Re: Remedial Investigation Work Plan Addendum #2

Former Luster-Coate Site, Site #C828113

Re: Luster-Coate, Site #C828113
Remedial Investigation Work Plan Addendum #2; May 18, 2020
Churchville (V), Monroe County

PROJECT/DRAWING NUMBER:
2171500
FIGURE 1

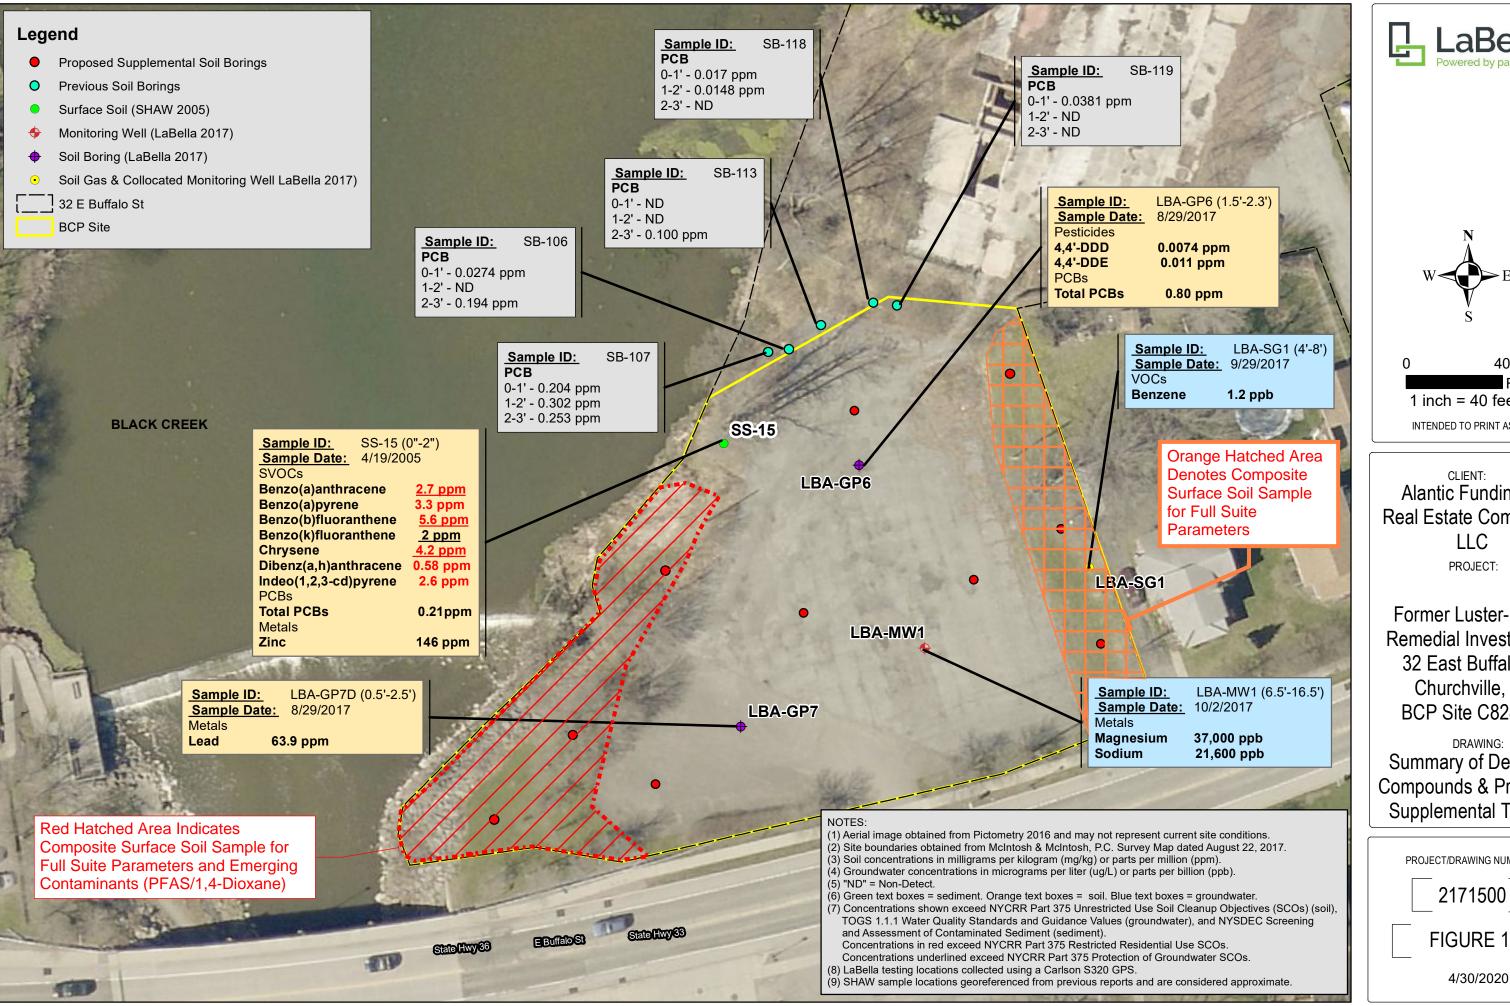
- 1. Depending on the results, additional investigation may be needed to define the nature and extent of contamination in the southern portion of the site.
- 2. The preliminary results will be included in the monthly progress reports and the RI Addendum Report will be submitted by **October 31, 2020**, unless an alternate date is approved by NYSDEC. The RI Addendum Report will not be formally reviewed by the Departments unless it is also intended to be the final Remedial Investigation Report for the southern portion of the site.
